ADDENDUM NO. 2

TO: PLANS AND SPECIFICATIONS FOR STATE OF MISSOURI

**Site Development and Security
Scruggs Station Warehouse
Project No. O2433-08**

SHEET NUMBER
C102
4 OF 5 SHEETS

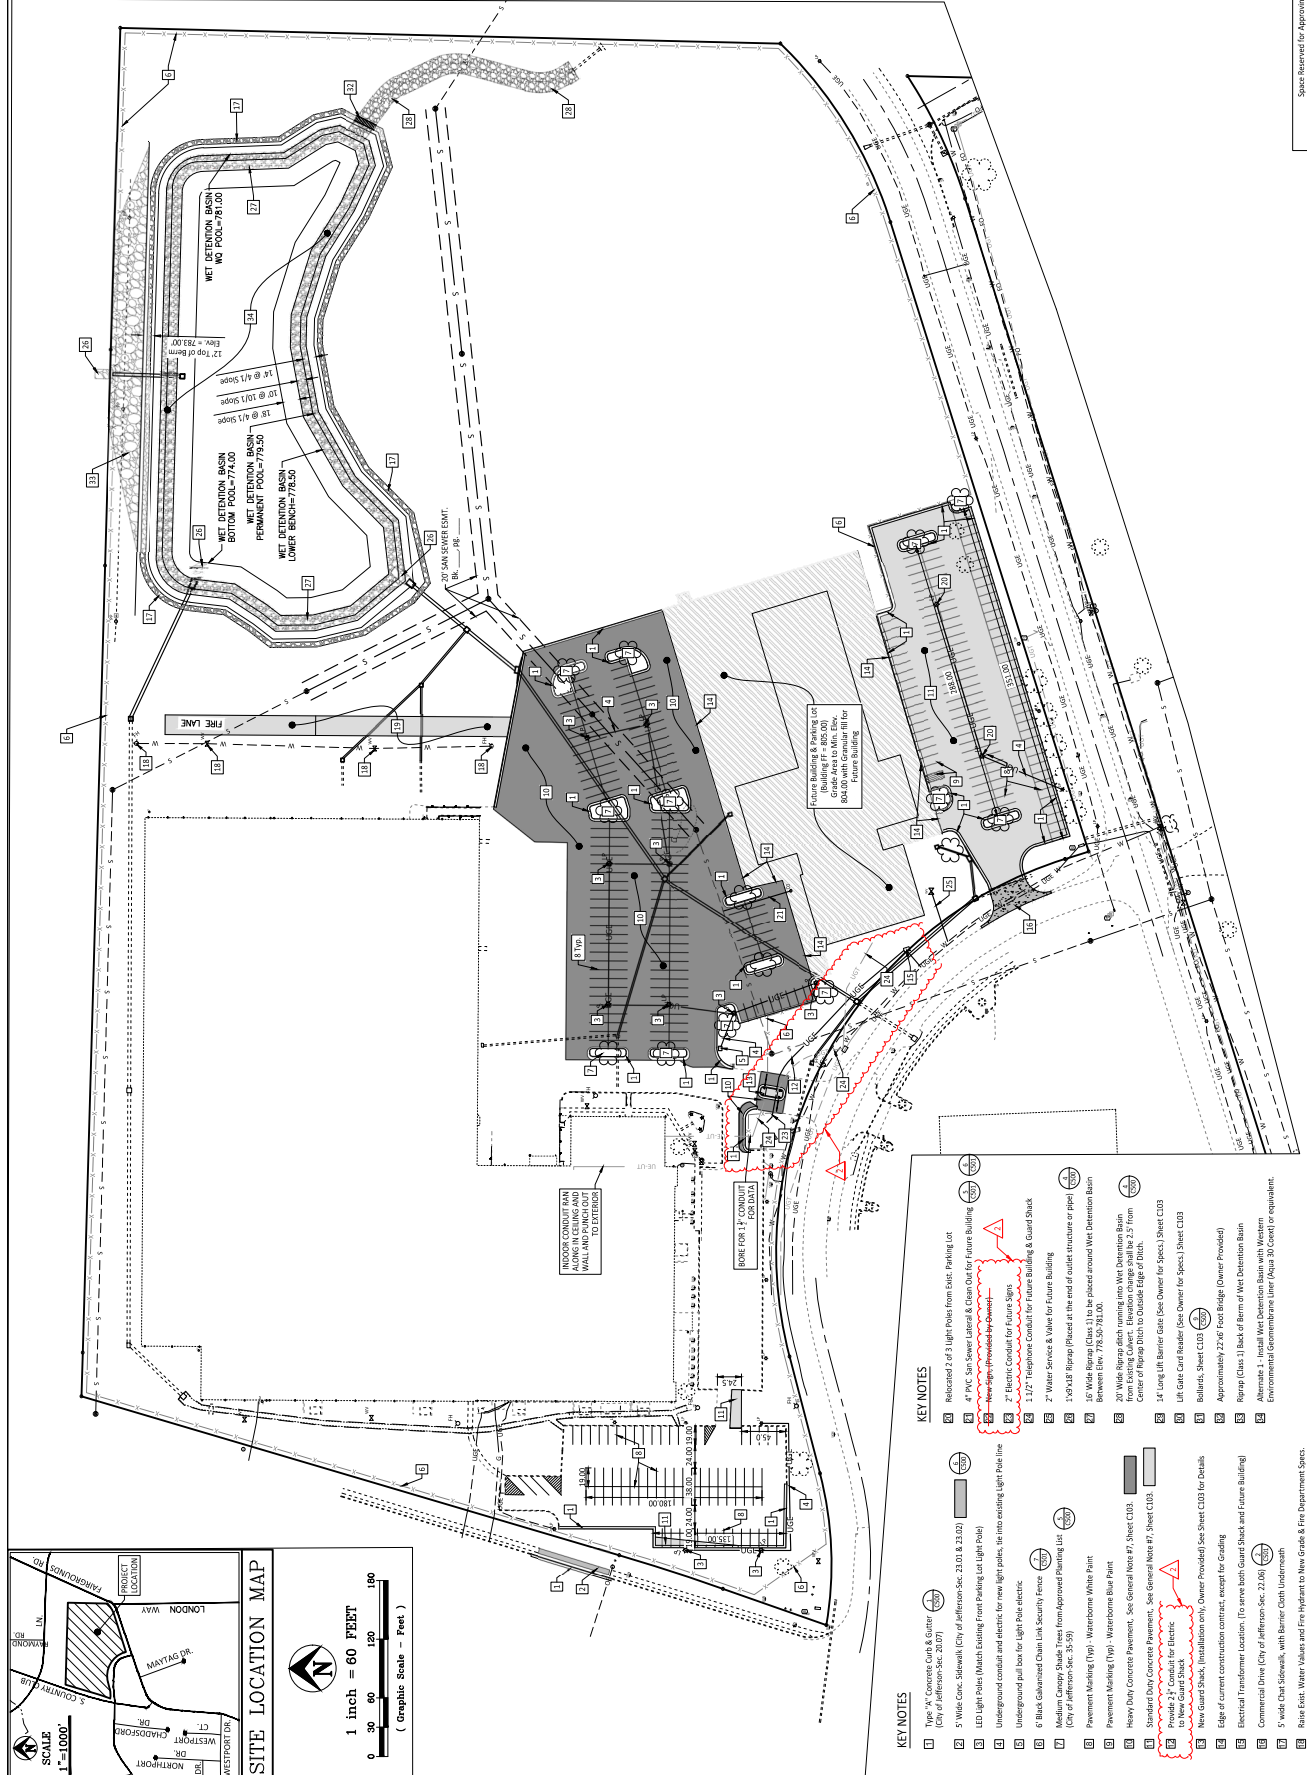
1. Sheet C102: Changed Transformer location and provided clarification on all stub outs for guard booth to be on south end nearest to street. Sheet C103 shows additional details on all line location moves.
2. Sheet C103: All stub outs for guard booth are to be moved to south end nearest to street. Sheet shows additional details on all line location moves.

Fence alignment needs to change to allow for future new sign location to be on outside of fence.

A: Sheets C102 and C103 have been marked indicating the electric conduit to the location of the existing sign that is being removed. This shall be 2" conduit. The new sign to replace of the existing one being removed is not included in this project.

A: Sheet C102 has been marked to indicate new location of Transformer and temporary meter-base and electrical panel shall be placed near transformer.
